TOWN OF NEWBURGH
PLANNING BOARD
TECHNICAL REVIEW COMMENTS

PROJECT: ZAZONE- 11 LOT SUBDIVISION

PROJECT NO.: 04-29

REVIEW DATE: 26 FEBRUARY 2021

BIORETENTION FILTER CROSS SECTION DETAIL

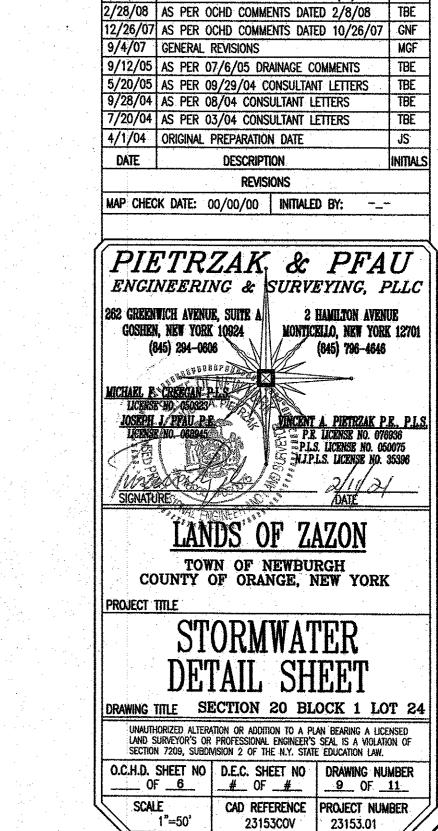
- **11.** Additional detail on the rain gardens including grading of the rain garden and sizing of the rain gardens on each of the lots must be provided.
